### Inland Transport Committee

#### Working Party on the Transport of Perishable Foodstuffs

### **Amendments to the comments to paragraph 4 of annex 2, appendix 1 of the ATP Handbook: Location of temperature measurement probes during transport**

**Transmitted by the Government of France**

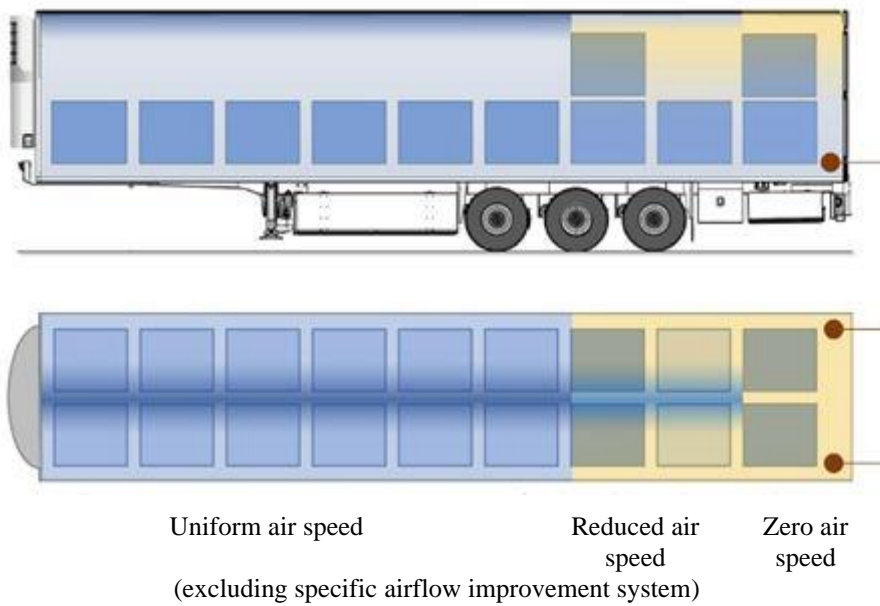
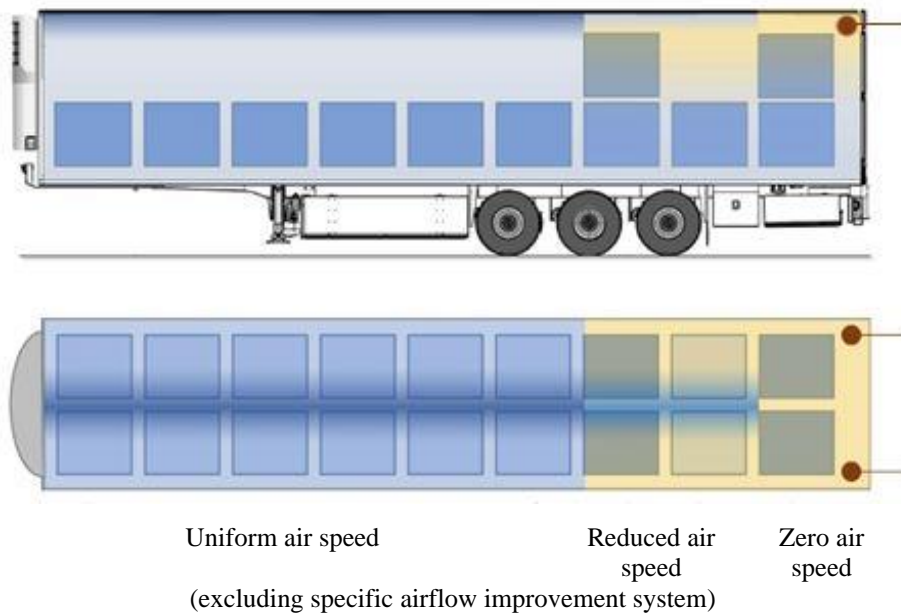
1. The placement of evaporators during construction can produce measurements that are distorted in comparison with “standard” configurations imagined when the locations were defined for the temperature sensors used for temperature control during transport.
2. The furthest opening is not necessarily opposite the refrigeration unit (there may be a side door, or an evaporator placed in the middle of the body and blowing across it, or located at the rear of the body and blowing towards the front, etc.).
3. If, owing to insufficient air flow, the cargo starts to warm up, the surrounding air layer will continue to be cooled and will stagnate at the bottom. There is thus a risk of delayed detection of the air temperature deviation from the upper part of the body.

4. In annex 2, appendix 1, Comments to annex 2, appendix 1, paragraph 4, it is proposed to replace the current sentence: *“In the case of upper cold air distribution systems, near (to the left or right of) the bottom of the doorway furthest away from the refrigeration unit;”* with: *“In the case of upper cold air distribution systems, near (to the left or right of) the corner furthest from the evaporator outlets, at the top (in the upper quarter of the height);”*
